Addendum 3

Webster High School – Band Room & Greenhouse Additions w/ Site Improvements

10/6/2022

TO: ALL OFFICIAL PLAN HOLDERS

6 DETAIL AT LOW END RAMP
SCALE: 1 1/2" = 1'-0"

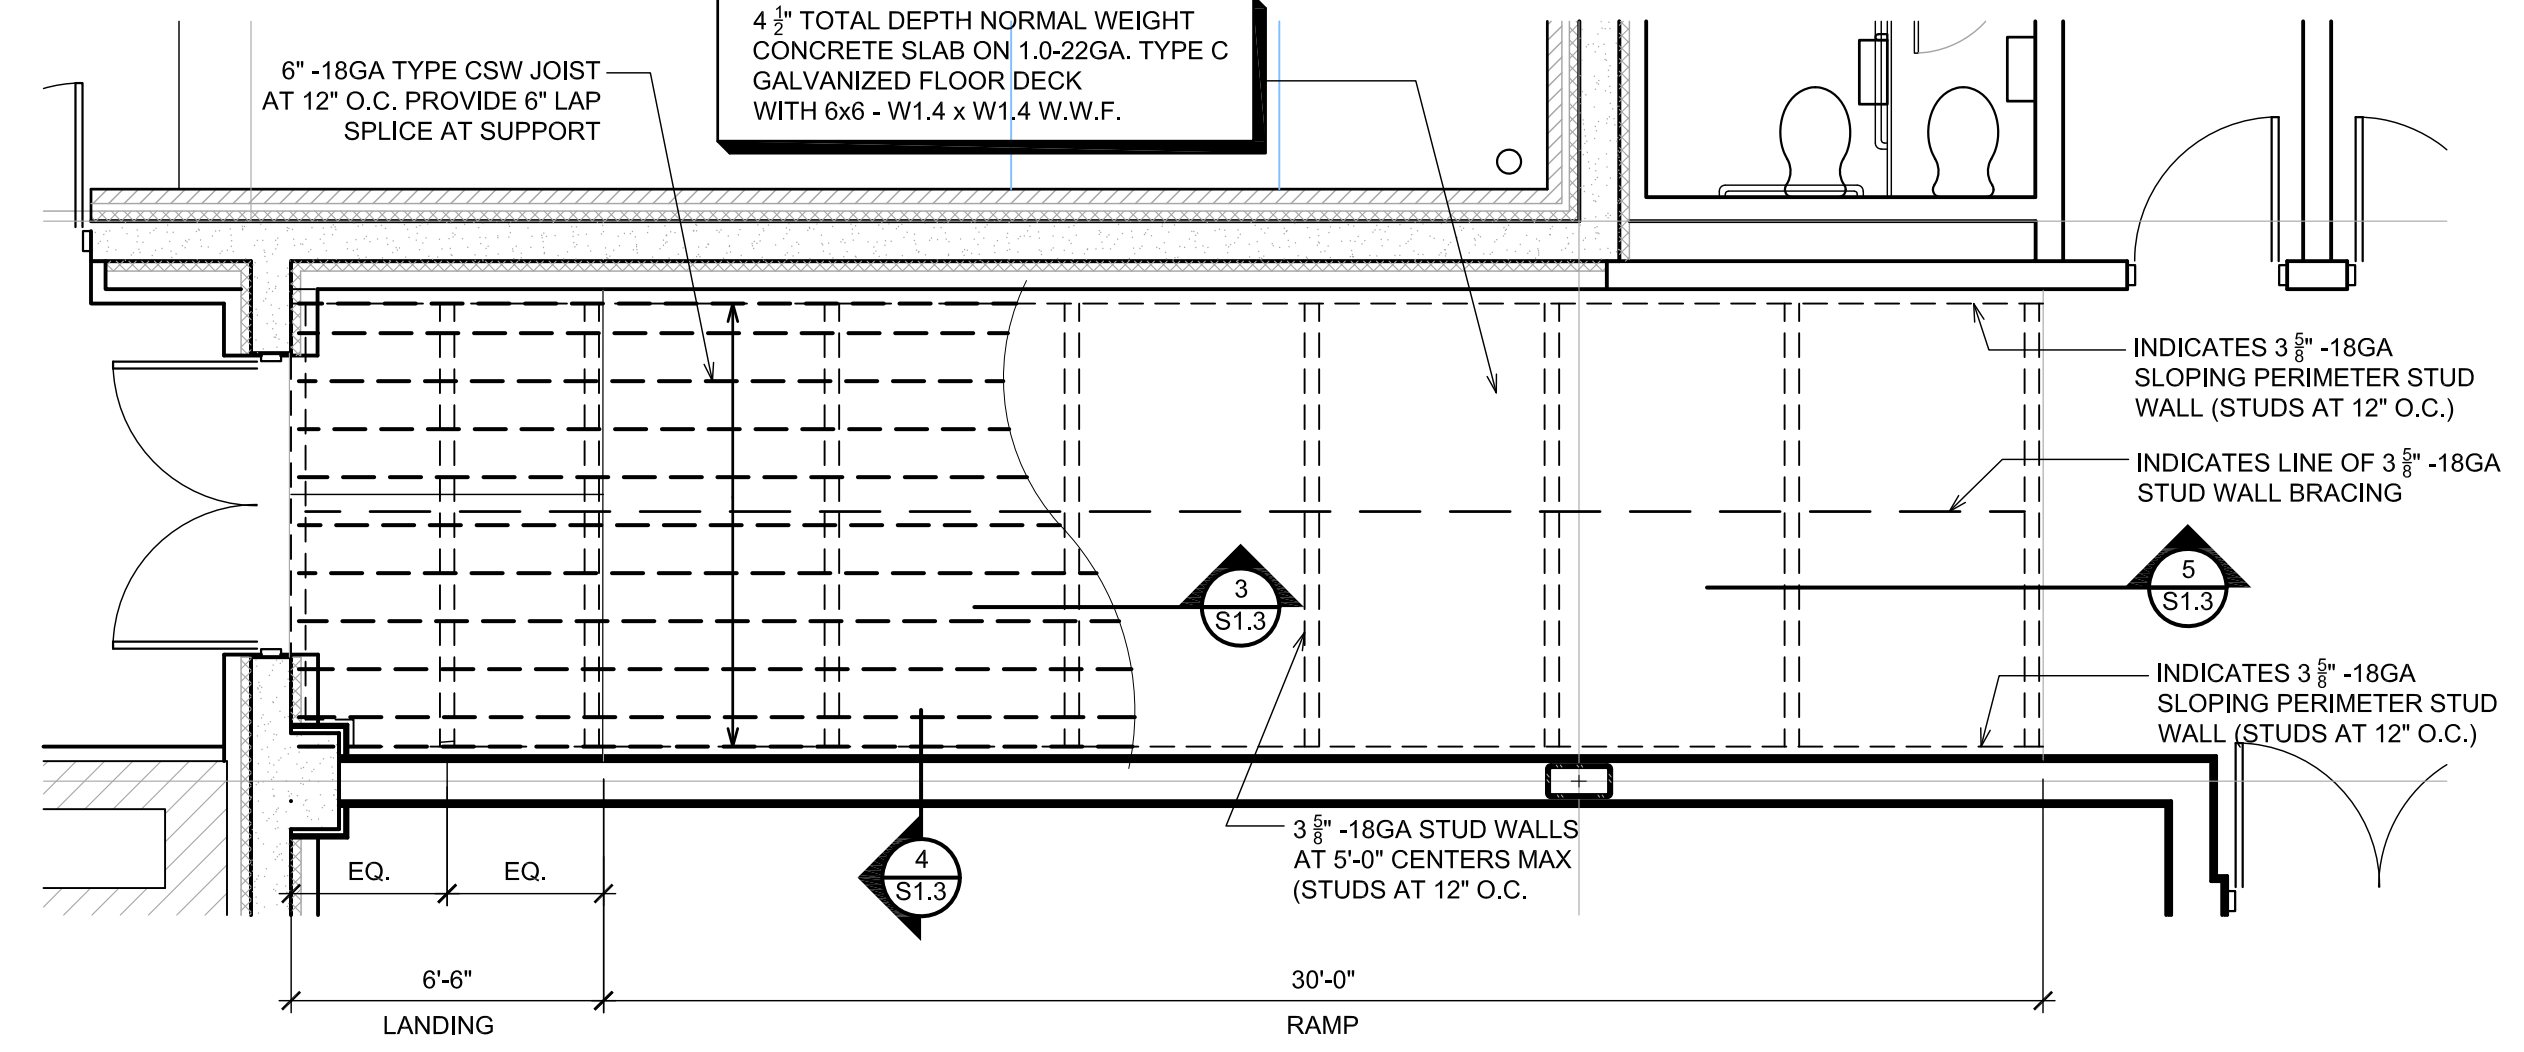
Item No. CM 1.26 **09.2 Flooring:** Include continuous wood floor reducer on sheet S1.3 detail 3.

- D. Sheet S1.2 – Details, Band Room Addition – Building “C”; revised sheet attached.
- E. Sheet S1.3 – Interior Ramp Framing Plan & Details; revised sheet attached.

2 ENLARGED WATER & GAS PLUMBING FLOOR PLAN-NEW
Scale: 1/4" = 1'-0"
GREEN HOUSE ADDITION BUILDING D

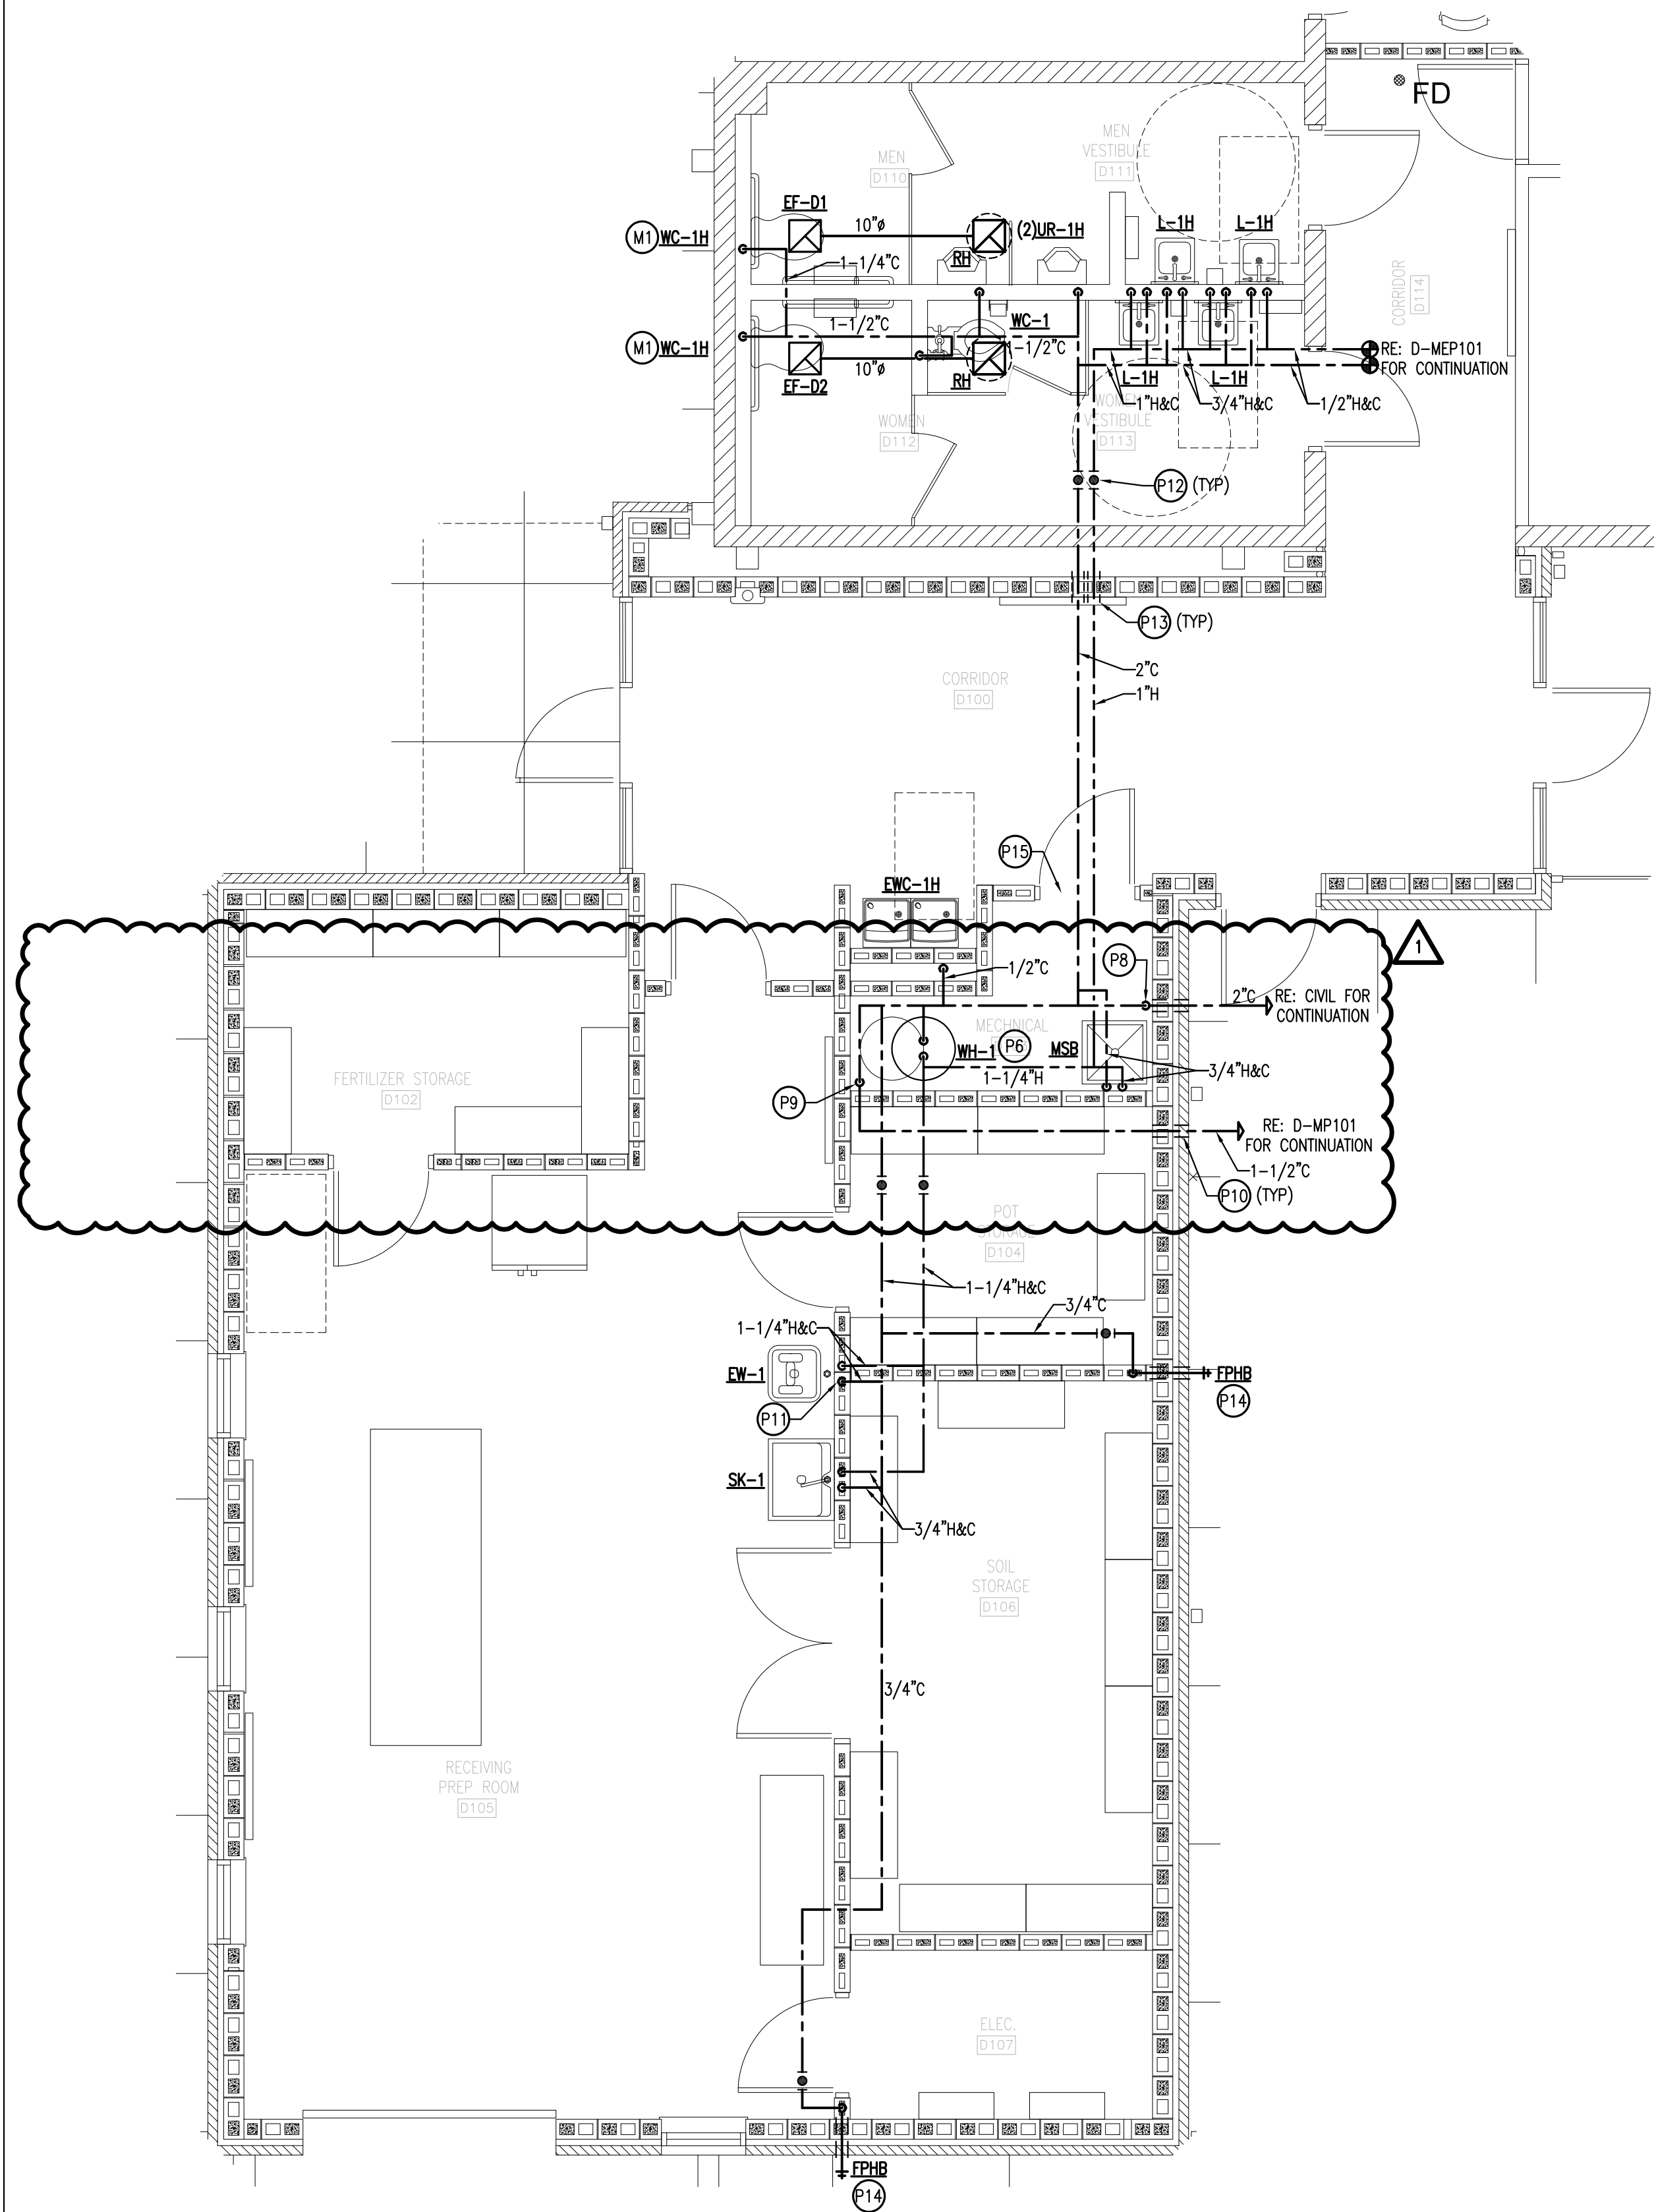
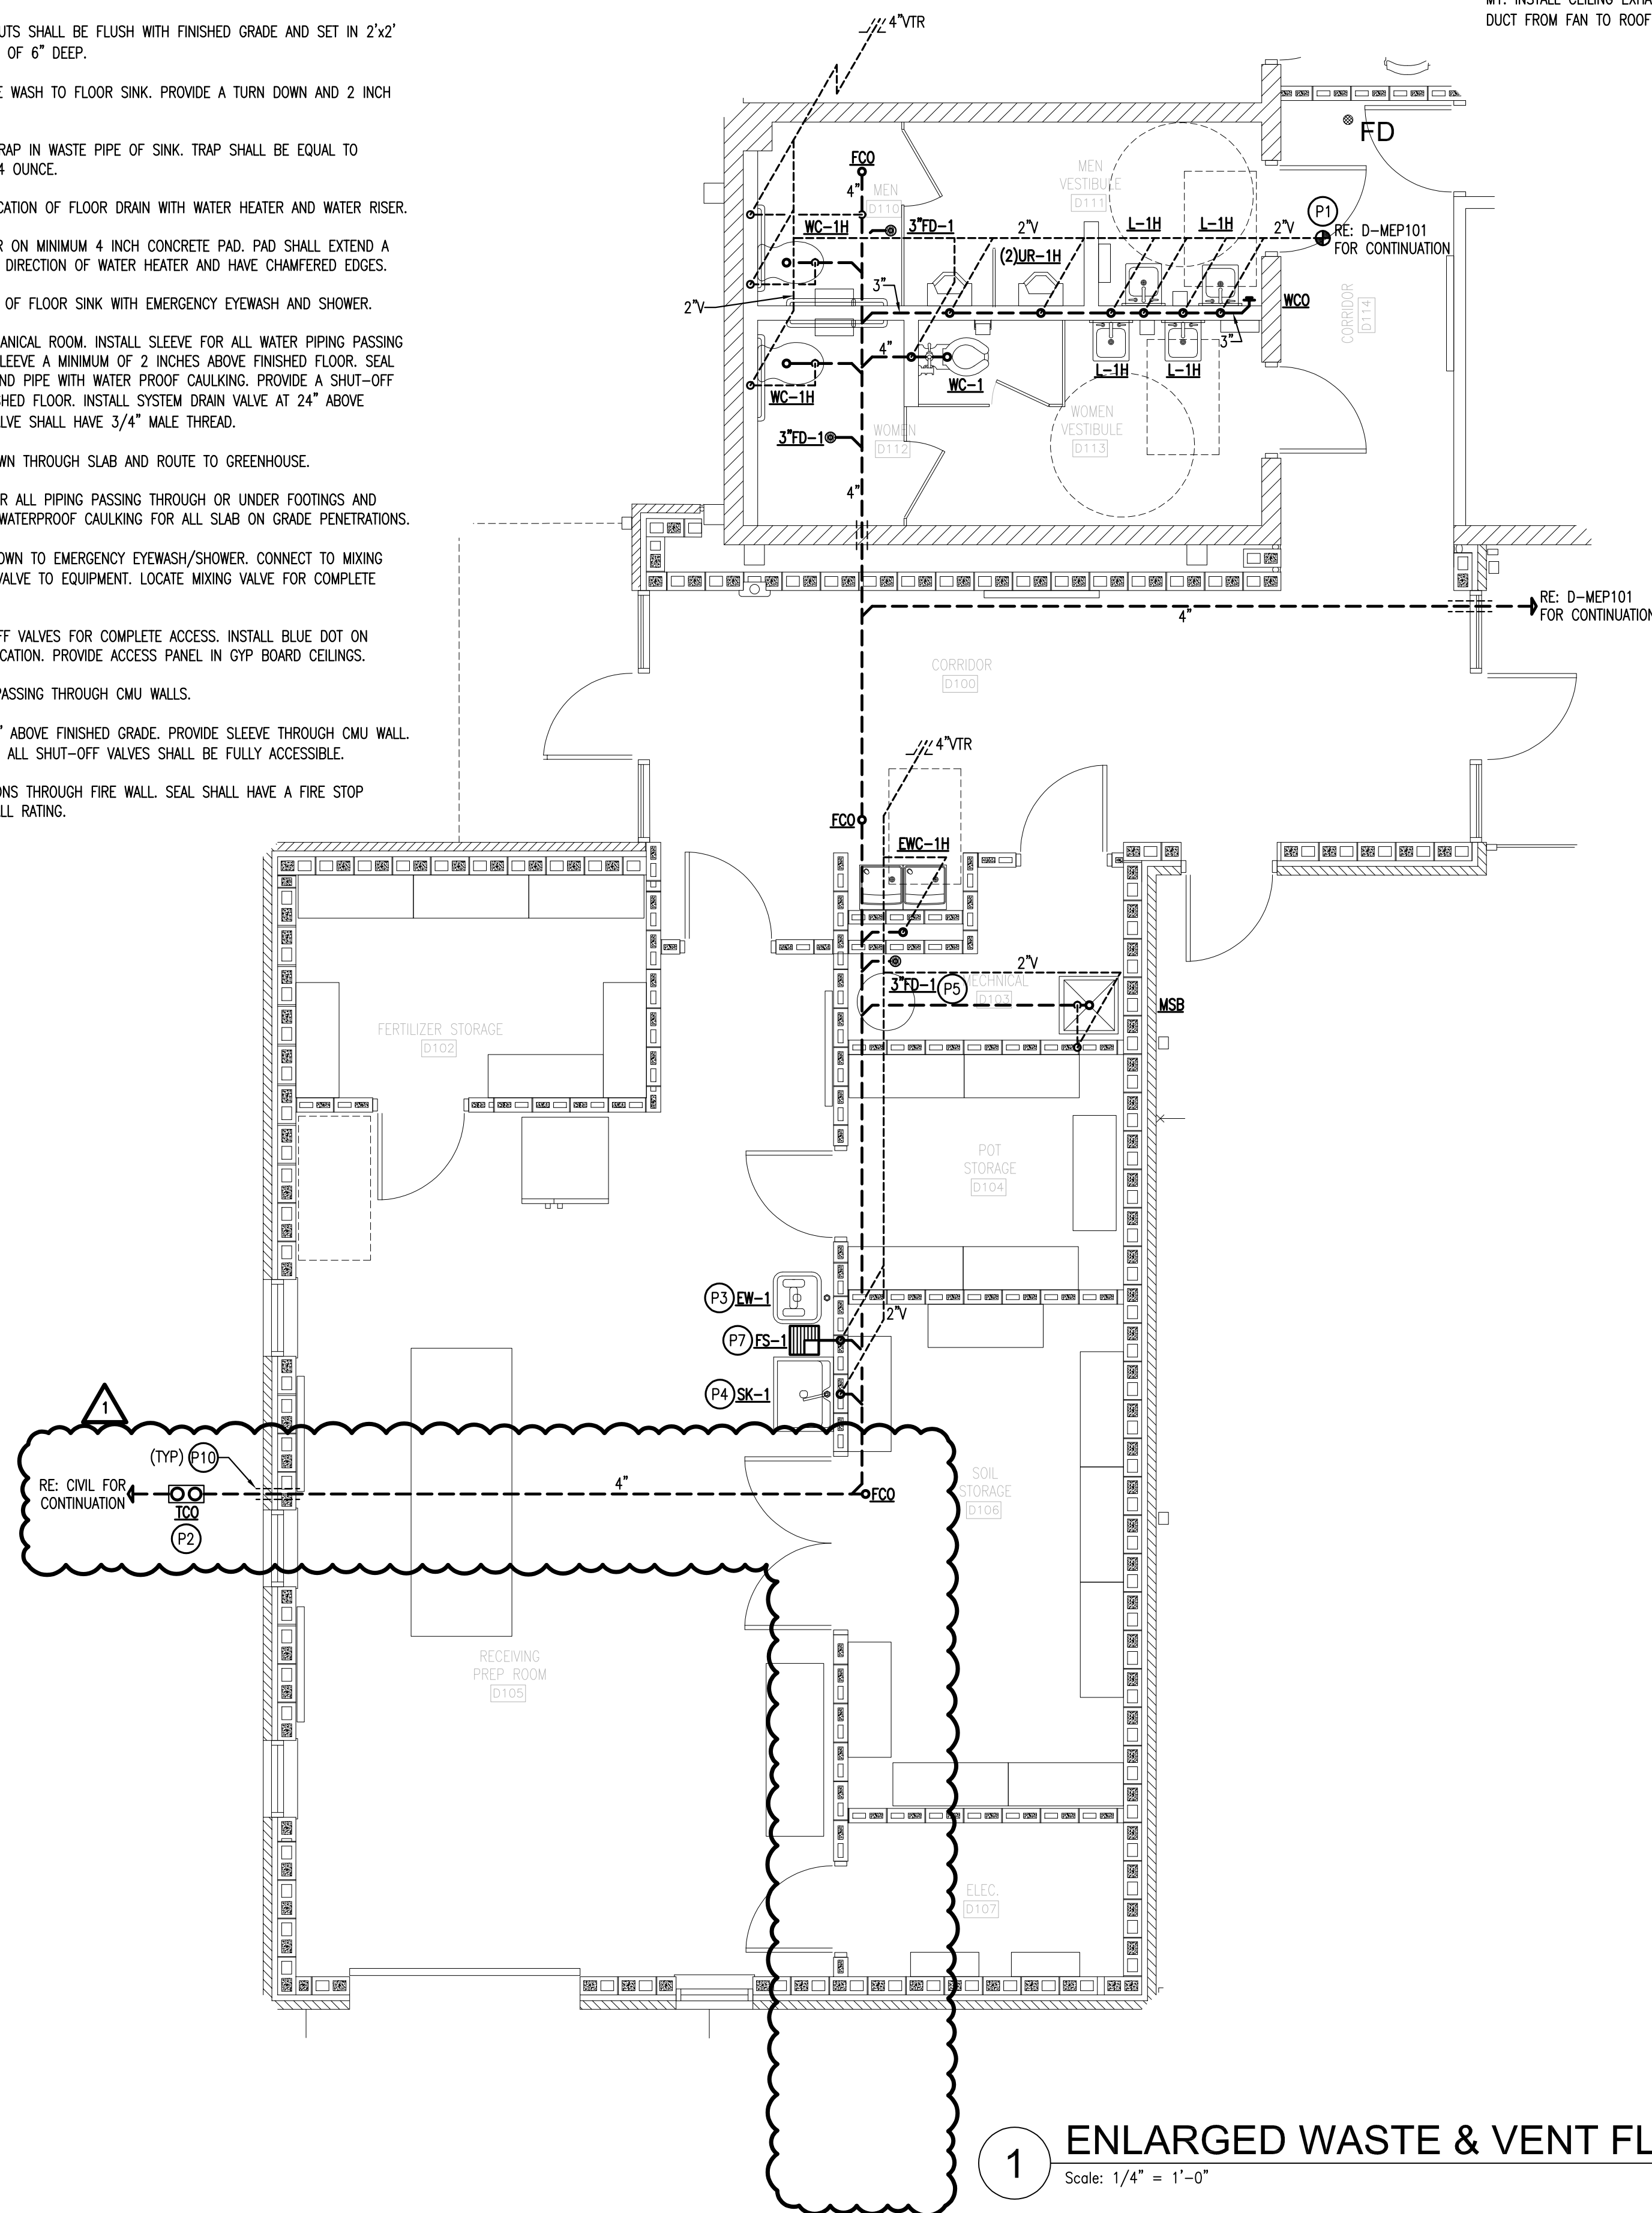
- M. Sheet D-MP102 – Enlarged Mechanical & Plumbing Floor Plans – Green House Addition Building “D”; revised sheet attached.
